SNUPPS

SLNRC 84-112 FILE: 0541/M-189  
SUBJ: Preservice Inspection Relief  
Request - Wolf Creek Plant

### RELIEF REQUEST FOR THE VOLUMETRIC PRESERVICE INSPECTION - WOLF CREEK REACTOR COOLANT SYSTEM BRANCH CONNECTIONS

FIGURE 01

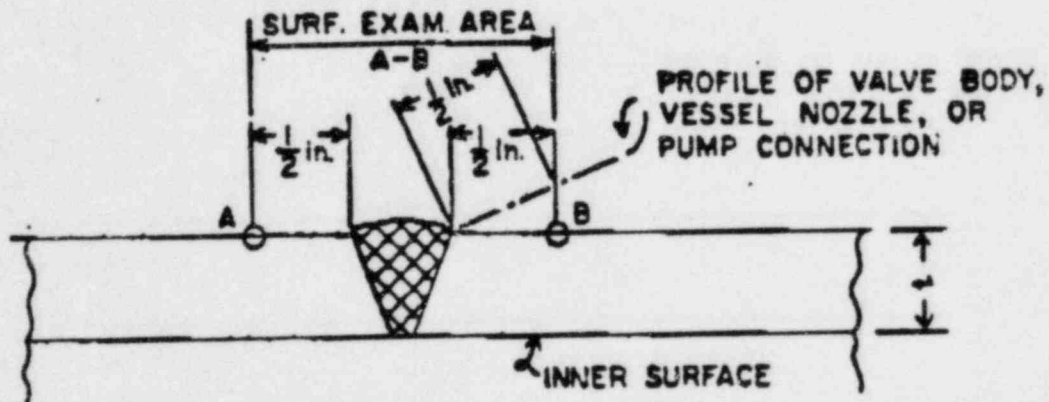
Figure 01 corresponds to Figure IWB-2500-8 of the Code and Figures 02 and 03 correspond to Figures IWB-2500-10 and 11, respectively, with the modifications as stated above. The preservice inspection examinations were performed to ultrasonically examine the defined volumes in Figures 02 and 03.

FIGURE 03

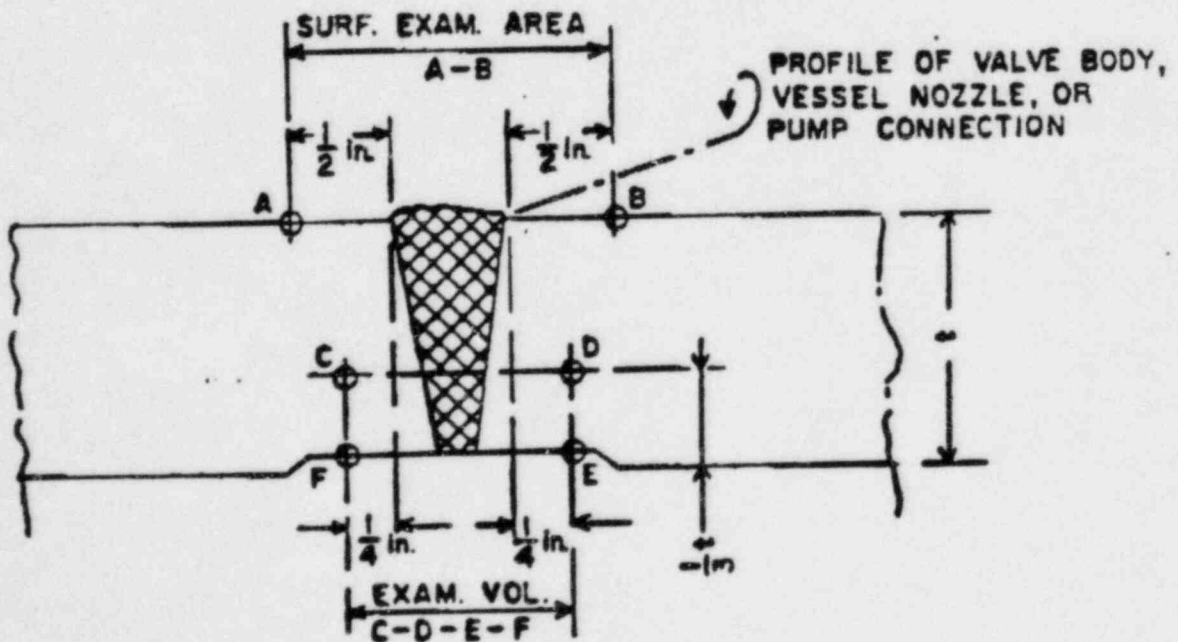
Due to the materials of construction (austenitic) and the design and fabrication geometry of corner type branch connections depicted in attached Figures 02 and 03, it is concluded that meaningful examination by ultrasonic methods is not feasible and that no other practical volumetric method is available.

<u>Item</u>	<u>W WELD #</u>	<u>KGE WELD #</u>	<u>SIZE</u>	<u>VOLUME UNEXAMINABLE</u>	<u>TYPE OF WELD</u>
<u>Loop 1</u>					
1	15	1BB 01 S102-3	12"	20%	Figure 03
2	17	1BB 01 S105-5	3"	75%	02
3	19	1BB 01 S101-5	4"	60%	02
4	21	1BB 01 S101-8	3"	75%	03
5	22	1BB 01 S101-9	3"	75%	02
<u>Loop 2</u>					
6	15	1BB 01 S202-3	6"	55%	03
7	17	1BB 01 S205-5	3"	75%	02
8	19	1BB 01 S201-5	4"	60%	02
9	21	1BB 01 S201-8	3"	75%	02
<u>Loop 3</u>					
10	15	1BB-01 S302-3	6"	55%	03
11	17	1BB-01 S305-5	3"	75%	02
12	21	1BB-01 S305-6	3"	75%	03
13	20	1BB-01 S301-5	3"	75%	03
<u>Loop 4</u>					
14	15	1BB-01 S402-3	14"	10%	03
15	16	1BB-01 S402-4	12"	20%	02
16	18	1BB-01 S405-5	3"	75%	02
17	20	1BB-01 S401-5	3"	75%	02
18	22	1BB-01 S401-6	3"	75%	02

As an alternative, VT-2 examinations for leakage will be conducted in accordance with IWA-5240. These will be carried out during the leakage test specified under IWB-5221. The combination of required surface examination, visual examination for leakage and the Code required fabrication examinations will establish the integrity of the as-built pressure boundary.
